## Response to Issues raised on the NHM-10X FCC Application

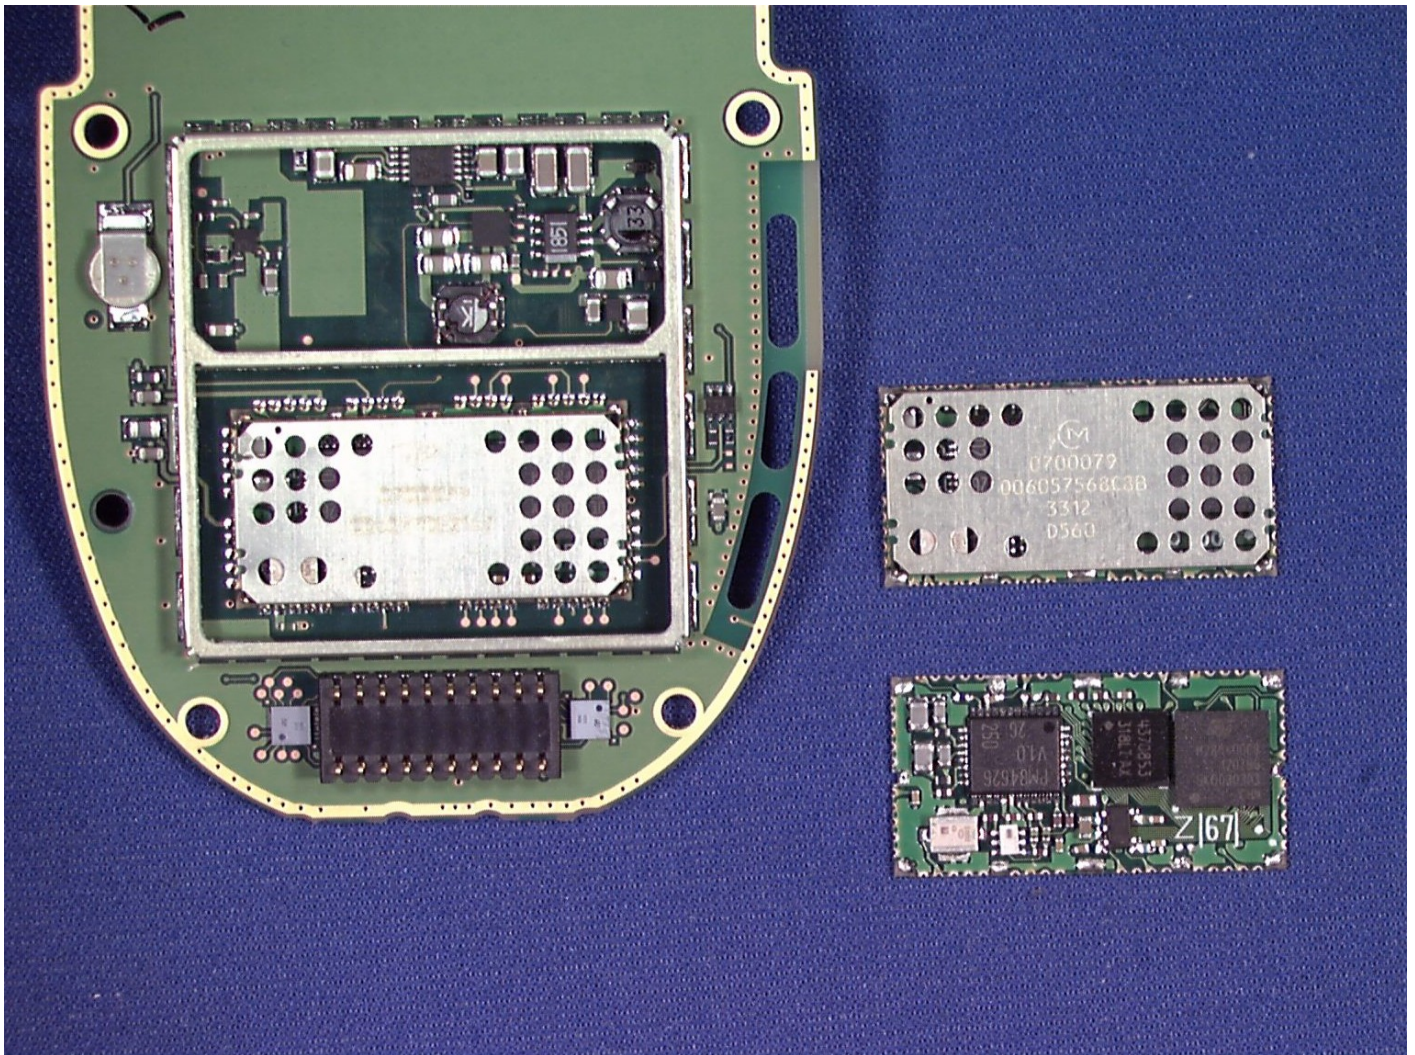
1) Please provide an additional photograph with the second sub-shield removed (page 6 of 8 in the Internal Photos exhibit).

Response 1) The shield to which you refer is the shield associated with the Bluetooth Module, which is used in its entirety in the design of this product. To clarify the use of the module within the device, similar modules have been photographed (in the same orientation, with and without shield) adjacent to main circuit board.
